<b>Product/Process Change Notice (PCN)</b>																					
<input type="checkbox"/> Major Change <input checked="" type="checkbox"/> Minor Change																					
<b>PCN Number:</b> PCN_FrqSPXO_20250218  <b>Affected Series:</b> WE-SPXO  <b>Affected Part Number:</b> See table below  <b>PCN Date:</b> 2024-11-18 (YYYY-MM-DD) <b>Effective Date:</b> 2025-02-18 (YYYY-MM-DD)	<b>Change Category:</b> <input type="checkbox"/> Equipment/Location <input checked="" type="checkbox"/> General Data <input type="checkbox"/> Material <input type="checkbox"/> Process <input type="checkbox"/> Product Design <input type="checkbox"/> Shipping/Packaging <input type="checkbox"/> Supplier <input type="checkbox"/> Software																				
<b>Contact:</b> Product Management  <b>Phone:</b> +49 (0) 7942 - 945 5001  <b>Fax:</b> +49 (0) 7942 - 945 5179  <b>E-Mail:</b> pcn.eisos@we-online.com	<b>Datasheet Change:</b> <input checked="" type="checkbox"/> Yes <input type="checkbox"/> No  <b>Attachment:</b> <input type="checkbox"/> Yes <input checked="" type="checkbox"/> No																				
<b>DESCRIPTION OF CHANGE:</b> <p>Because of a database mismatch, Würth Elektronik eiSos will correct the packagi

2. Correction of the Solder Pad Layout:

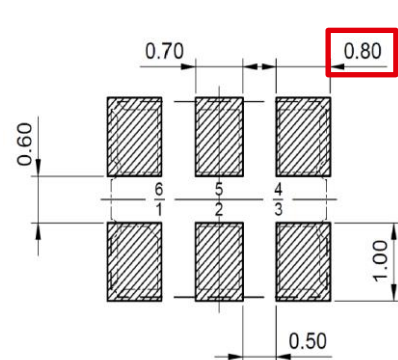
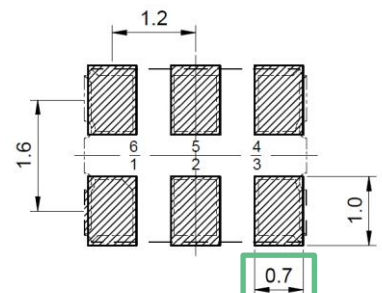
Affected Part numbers	Before	After
Solder Pad Layout	830208332209 830207511509 830208332309 830208331709 830208331909 830208332009 831080290 830207366709 830207628309 830208485909
